**Written Representations  
for the  
Royal Society for the Protection of Birds**

**Application by Norfolk Boreas Limited for an  
Order Granting Development Consent for the  
Norfolk Boreas Offshore Wind Farm**

**Planning Inspectorate Ref: EN010087**

Fig. 3: Flamborough/Bempton Black-legged Kittiwake productivity 2009 – 2017, mean of plot results plus/minus SE.

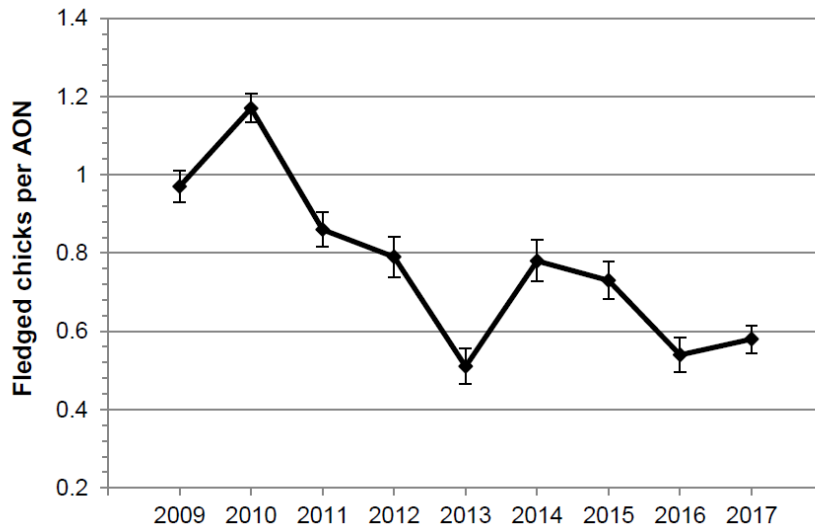
4.3.14 The further claim in para. 260 that tagged birds were more likely to have failed is also incorrect. For the FAME and STAR data, where remote download tags were used, birds were re-caught, in order to retrieve the tag, on the nest, so it is impossible to re-catch tagged birds if they have failed breeding as they would not return to their nest, or sit tight on the nest, if they were not protecting chicks. Ponchon *et al.* (2015)<sup>55</sup>, cited in para 260, did show prospecting movements in birds that fail early during the breeding season (during incubation). However, citing this incorrectly implies that FAME/STAR birds were unsuccessful breeders. Furthermore, the 2017 tagging work at Flamborough and Filey coast SPA, using tags weighing less than 3% body weight, did include failed birds, as there was no need to recapture due to different tag technology, and it was possible to compare these with successful breeding birds. The comparison showed that failed breeders made
